TO: DEVELOPMENT REVIEW BOARD
FROM: CURRENT PLANNING SERVICES
SUBJECT: CASE 78-DR-2003
REQUEST: Approve site plan & elevations for a new 3-story building at the Scottsdale Healthcare Shea campus
PROJECT NAME: Medical Plaza 5
LOCATION: 10040 N 92nd St

STAFF RECOMMENDATION: APPROVE subject to the attached stipulations.

Stipulations for Case: Medical Plaza 5 – Scottsdale Healthcare Shea Campus 78-DR-2003

SITE PLAN

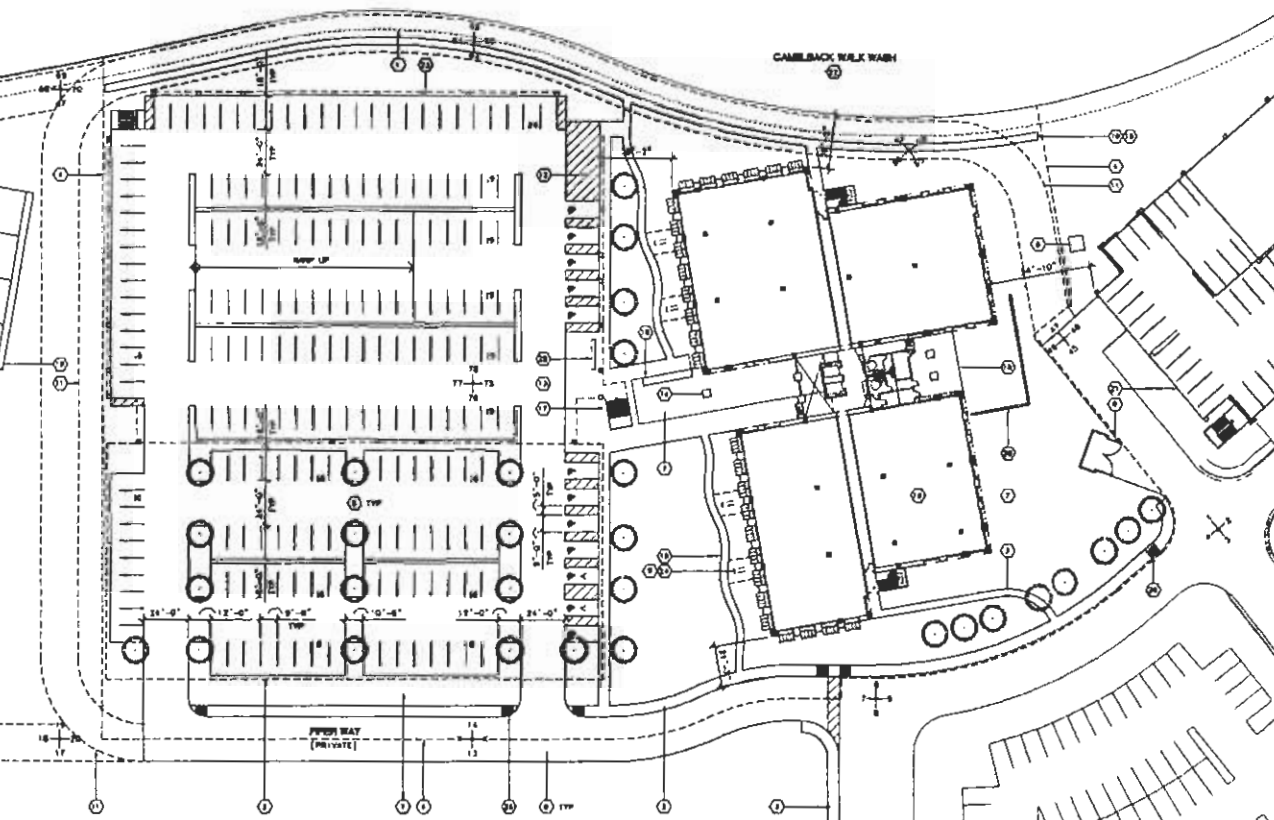
- A. The pedestrian connection south of the building and north of the parking garage that runs east and connecting to the Camelback Wash to the internal street shall be a minimum of 5-feet in accordance with the master plans approved with Zoning Case 44-ZN-1990.

- B. The parking garage shall be setback from the east property line a minimum of 10-feet in accordance with Zoning Case 44-ZN-1990
- C. Covered van accessible stalls and standard accessible stalls shall be provided at an equal ratio / percentage of covered standard parking.
- D. The parking lot shall be setback from the north-south private drive's west back of curb a minimum of 20-feet. The 20-feet shall not include the parking stall's overhang.
- E. The future parking garage expansion shall be set back from the north-south private drive's west back of curb a minimum of 20-feet.

Need to show and construct a pedestrian path to the south of the property that connects to the greenbelt path.
